I have considered the submitted information for the application APP/22/00587 and was interested if the agent would consider amending the drainage details to reduce the impact on the RPA of the trees? This would be in relation to condition 10.

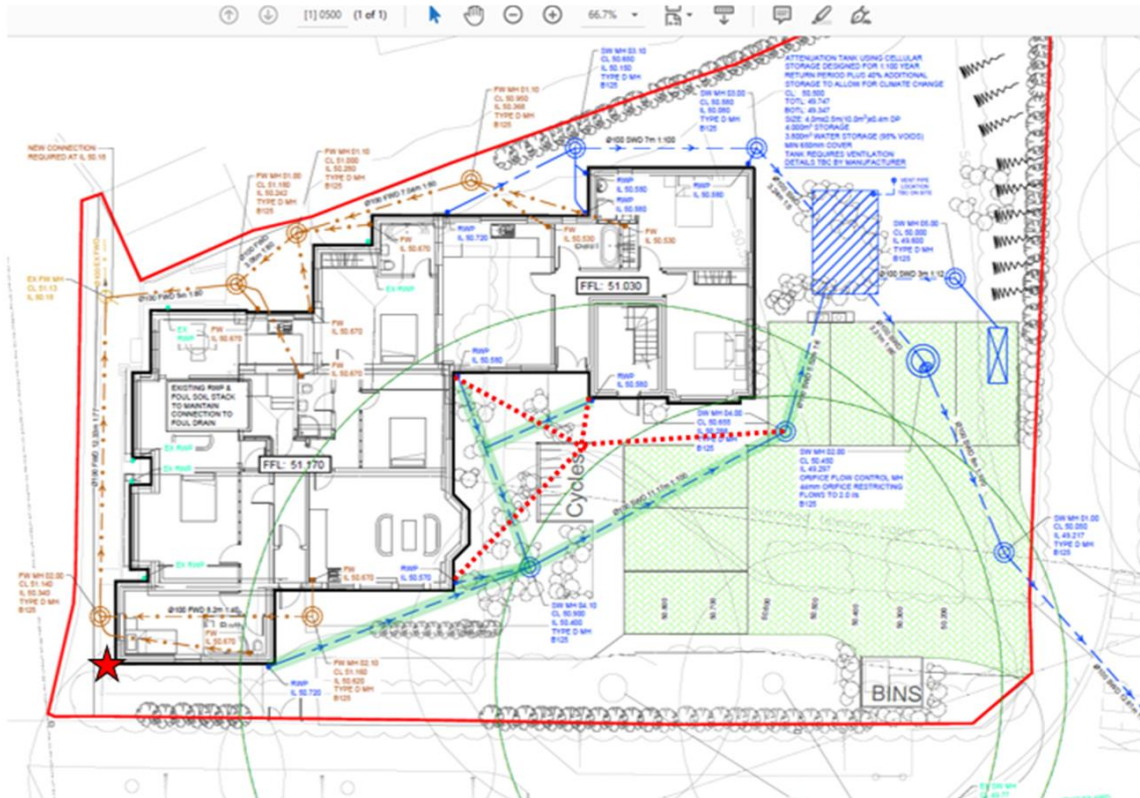
The red dotted line is a potential alternative SWD to try and reduce the impact on the RPA.

I had a query with the RWP (shown as a red star on the drawing below) on the south eastern corner that connects up to a manhole to the south of the proposed cycle parking. Could this RWP be located on the south western corner and connect to the existing SW drainage on the western boundary? The existing SW drainage on the western boundary is not shown, could this alteration work?
